# OEI<sup>®</sup> Memo

**RE:** Series XXI Pedestal Lock Bars & Lock Pins

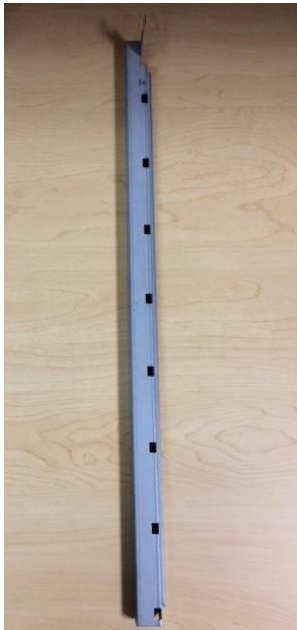
The Series XXI Pedestal Lock Bars and the Lock Pins are being changed to a new style Lock Bar and Pins that are more rigid and function easier in the pedestals.

**Old Style Lock Bars:**

- 2.KP40296.6 – 6 hole lock bar
- 2.KP40296.7 – 7 hole lock bar
- 2.KP40296.8 – 8 hole lock bar

**New Style Lock Bars:**

- 2.KP40279.6 – 6 hole lock bar
- 2.KP40279.7 – 7 hole lock bar
- 2.KP40279.8 – 8 hole lock bar

**Old Style Lock Pins:**  
2.KP20280 – Lock Pin

**New Style Lock Pins:**  
2.KP20278 – Lock Pin

The new Lock Pins snap onto the new Lock Bars according to the same configuration chart in the assembly instructions.

**NOTE: Current Pedestals that already have the Old Style Lock Bar and Pins in them CANNOT BE RETROFITTED with the New Style Lock Bar and Pins without changing out the suspensions also or it will not function.**
